SUBJECT: Forwards response to listed SER open items. Responses will be included in next FSAR amend.

Re: Nine Mile Point Unit 2
Docket No. 50-410

Enclosed for your use and information are the Nine Mile Point Unit 2 responses to the Nuclear Regulatory Commission's Safety Evaluation Report open items. This information has been previously discussed with your staff and is submitted to aid your review of the Unit 2 license application for the resolution of these open items. This information includes Safety Evaluation Report open items 3b, 4, 18, 51-9, 72c, 79, 93, 94, 99, 109, 123, 124, 125, 162, 430.2, 430.3, 430.58, 430.87, 430.97, 430.100, 430.105.

FIGURE 8.2-1

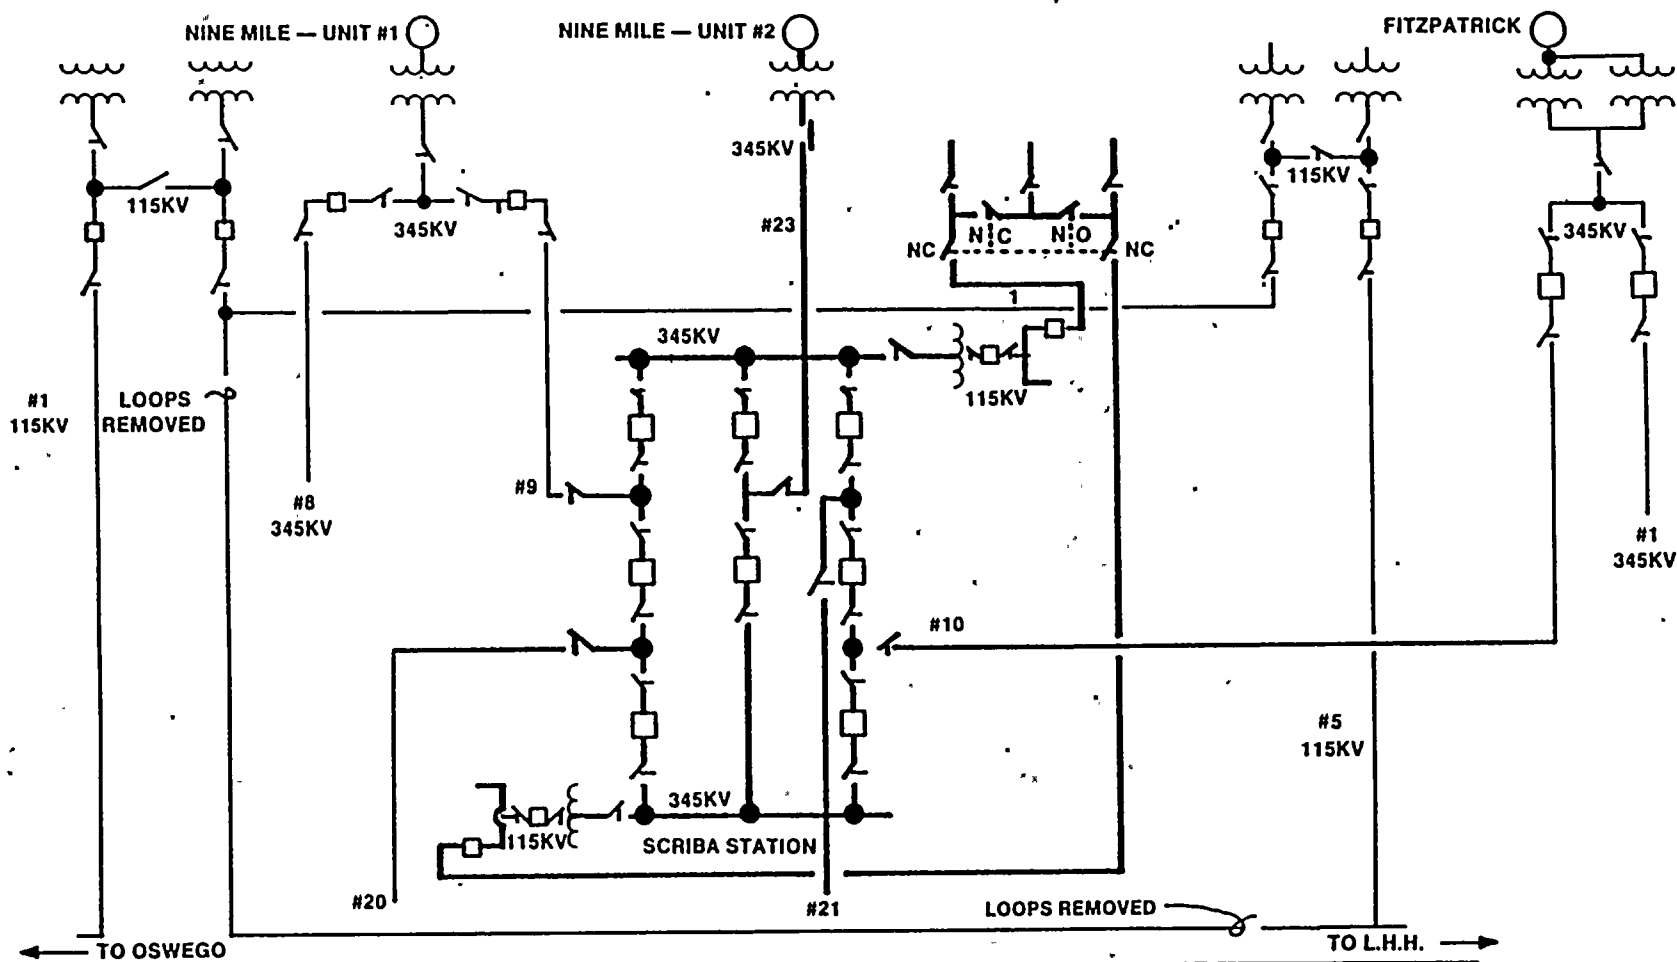
- a. A revised Figure 8.2-1 and narrative description of the new offsite power circuit configuration.
- b. Drawings of the physical orientation of the offsite circuits around the Nine Mile Point and Fitzpatrick Power Stations. Suggest using Figures similar to 2.1-2 and 2.1-3.
- c. Drawings which show tower spacing for lines which share a common right of way.
- d. Steady state and transient stability analyses results for the new offsite configuration including the loss of the largest capacity to the grid or removal of the largest load from the grid.

See revised Sections 8.1 and 8.2. A tower spacing drawing is not provided since the 115 kV is not on a common right-of-way. See Figure 430.7-1.

FIGURE 430.7-1

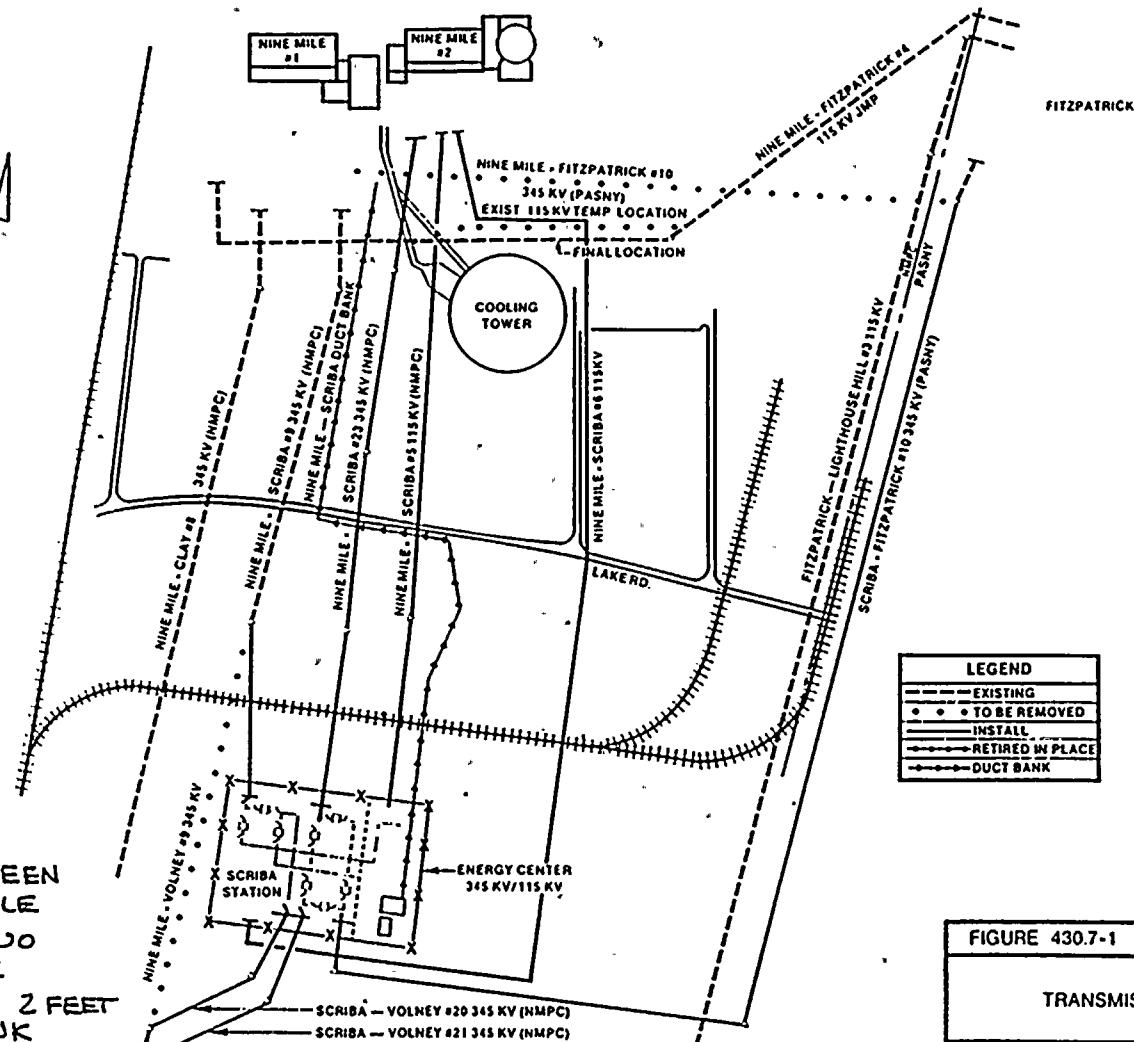
• It appears that the note on Figure 430.7-1 identifying line #21 as a potential addition is incorrect. Shouldn't it be line #20?

• Figure 430.7-1 shows only one duct bank between the Scriba substation and the Nine Mile Point Unit 2 115 kV switchyard. If the failure of the cables in the duct bank can cause a total loss of offsite power to NMP-2 verify that the reactor can remain in a safe condition (assuming onsite power is not available) for the period of time it takes to reestablish at least one offsite power circuit or provide a redundant duct bank. Describe the separation of the Scriba substation control circuits. If they are not separated provide the same analysis as requested above or provide separation.

FIGURE 1.2-17

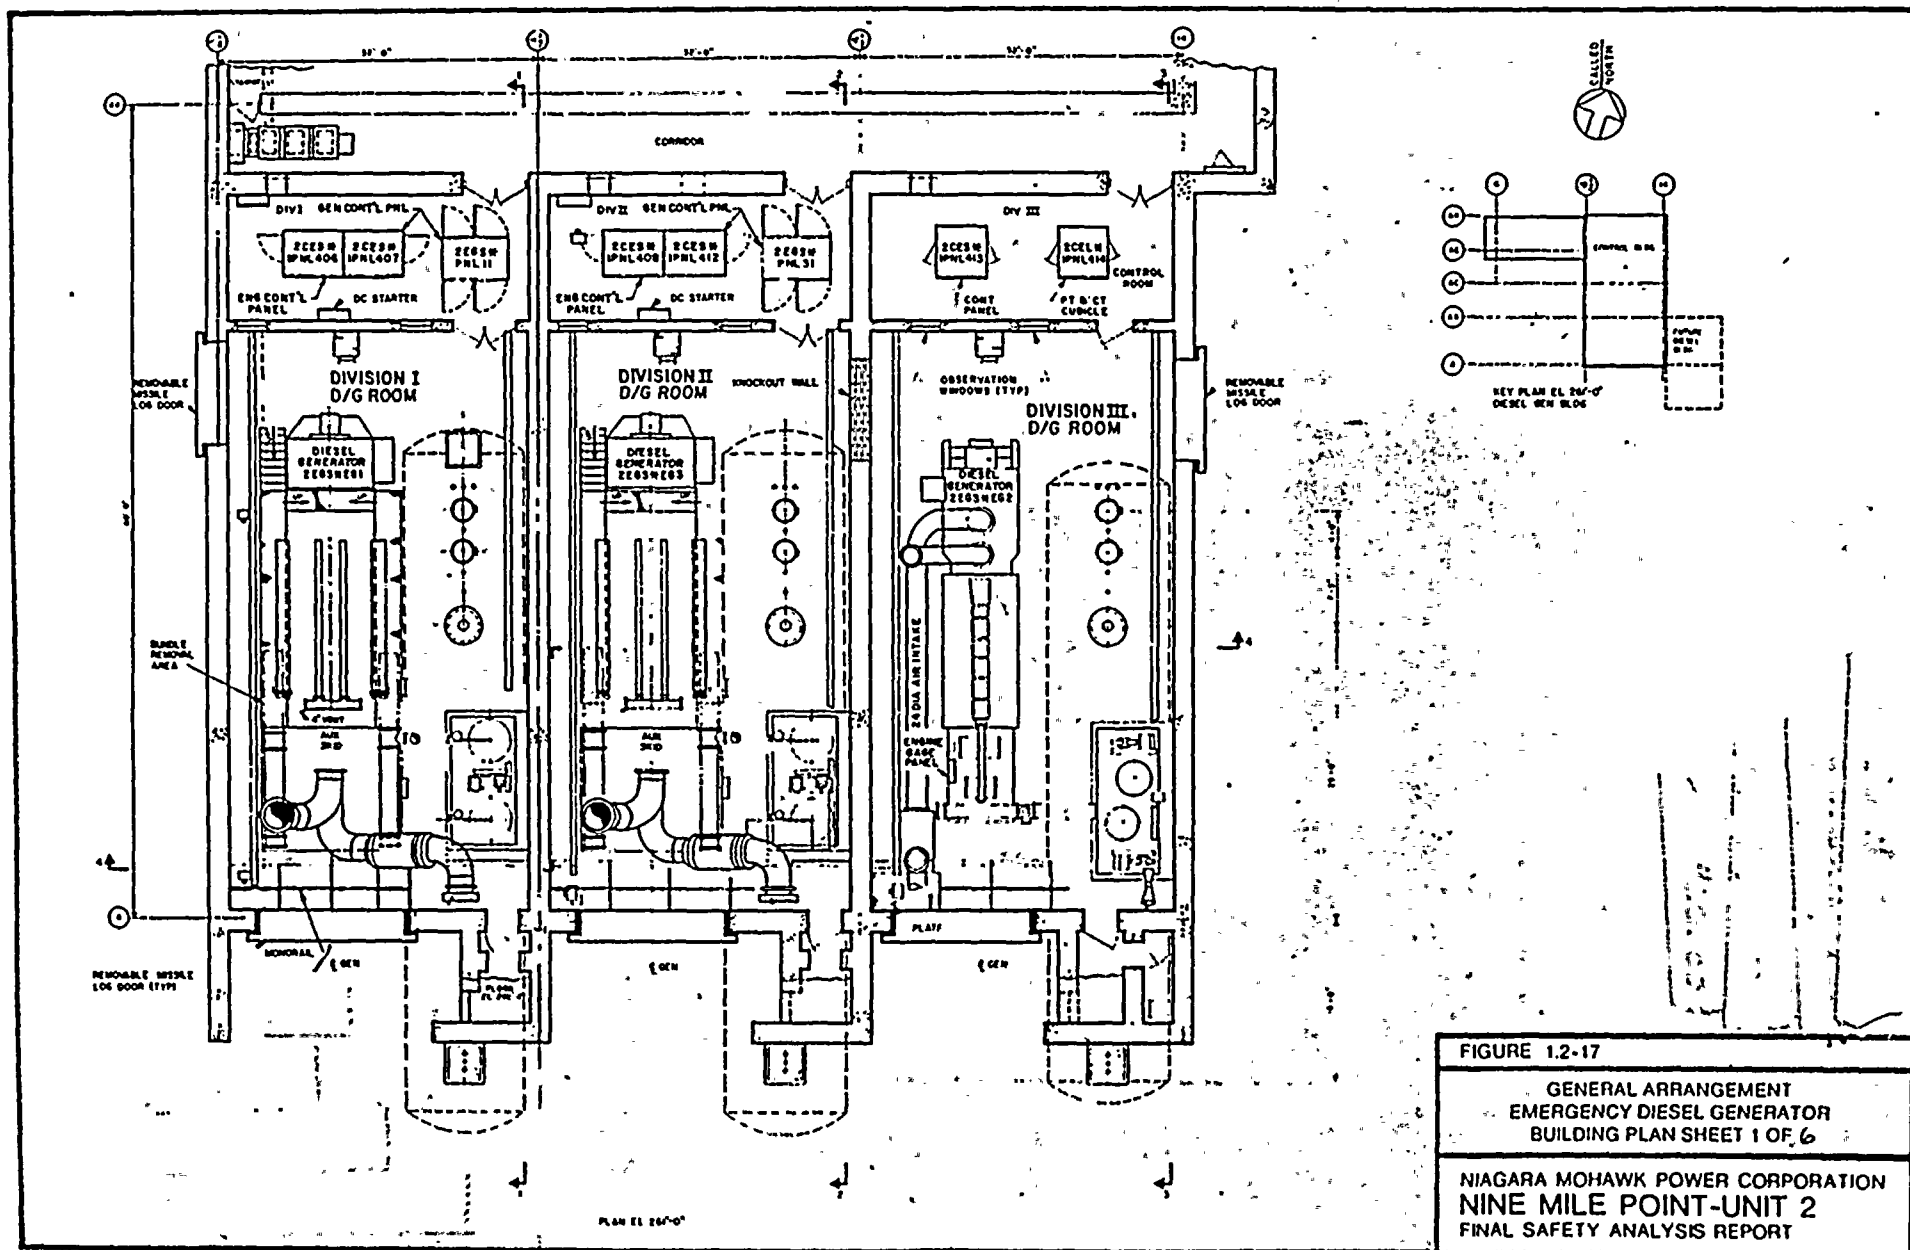
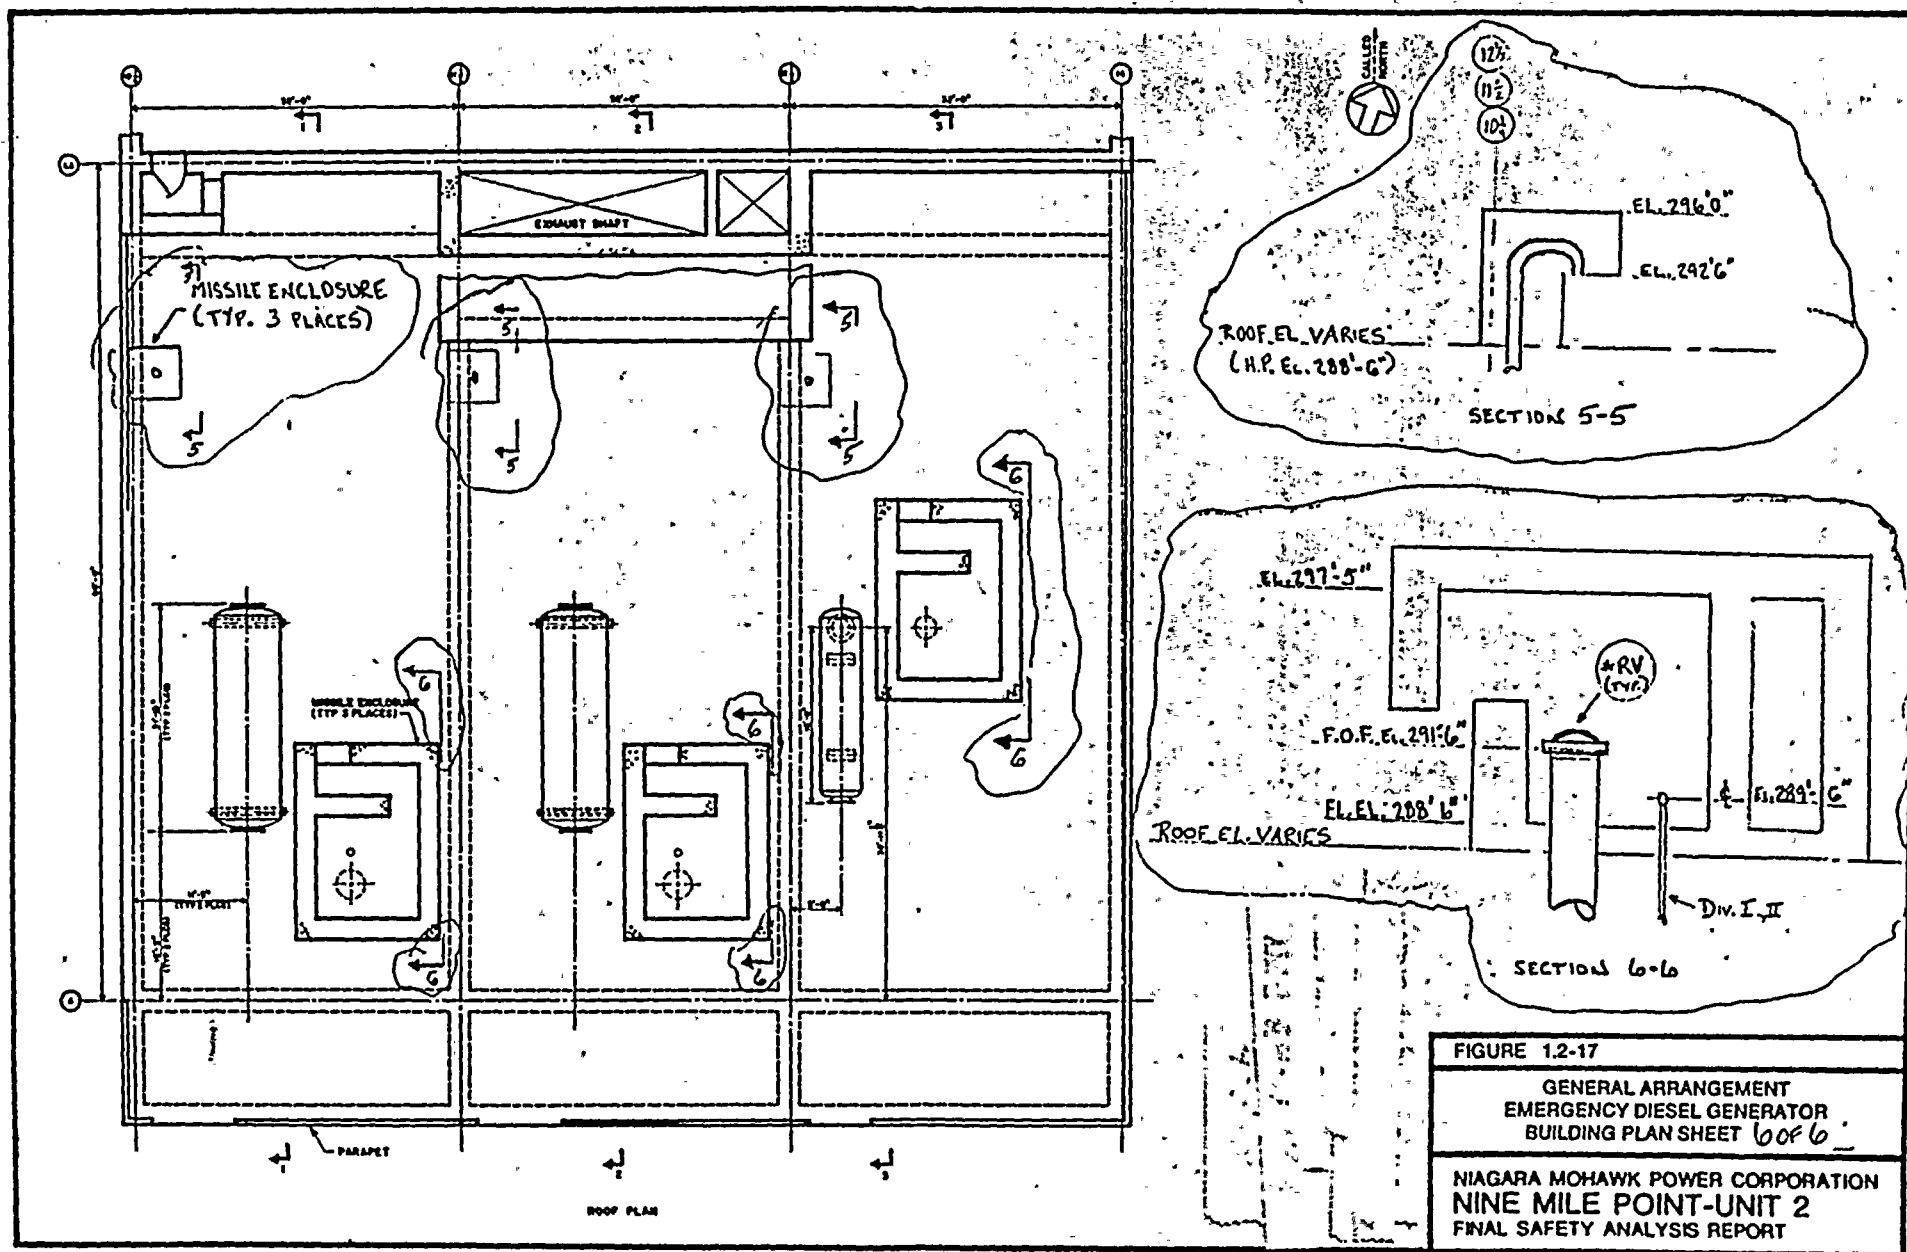
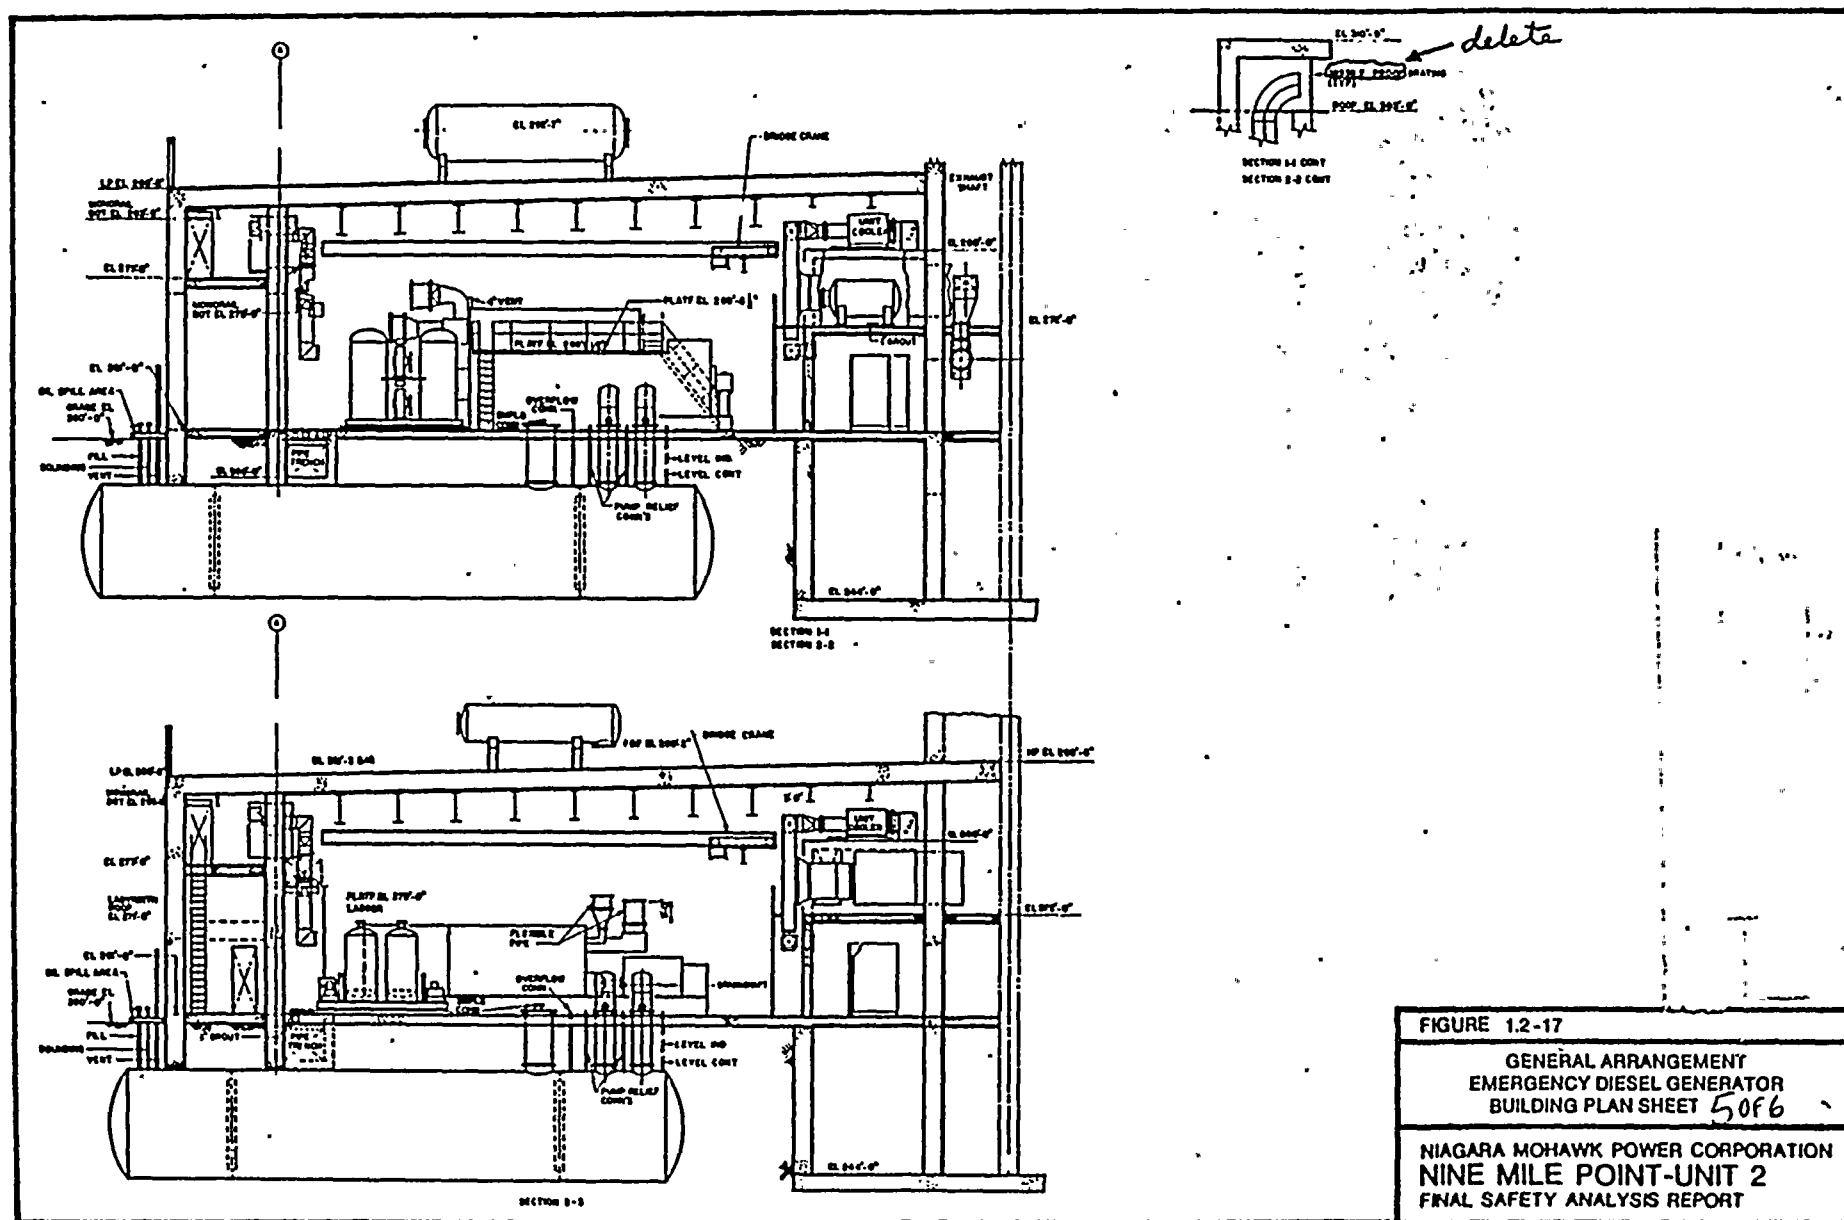
QUESTION F430.97 (9.5.8)	1.11
FSAR Figures 9.5-49 through 9.5-51, and 1.2-17 through 1.2-19, do not provide adequate details of the missile protection provided for the diesel generator combustion air intake and exhaust systems. Provide additional plan elevation, and section views, as required, which clearly show what the missile protection consists of, where it is located relative to the intakes and exhaust, and the relationship of the protective devices with the diesel generator building and other buildings, as appropriate. (SRP 9.5.8, Part I)	1.12 1.13 1.15 1.16 1.17 1.18 1.19
PSB COMMENTS	1.21
Not acceptable. It is still not clear from the FSAR text or figures how tornado missile protection is provided for the combustion air intake and exhaust systems. The requested additional plan, elevation and/or section views have not been provided.	1.23 1.25 1.26 1.27

RESPONSE	1.29
See revised Section 9.5.4.3.	1.30
RESPONSE TO PSB COMMENTS	1.33
See revised Section 9.5.8.1 and Fig. 1.2-17.	1.34

10. The missile enclosures appear in Figure 1.2-17 for diesel generator divisions I, II, and III. Section 6-6 on this figure illustrates the diesel exhaust relief valve missile protection.	1.20 1.21 1.23
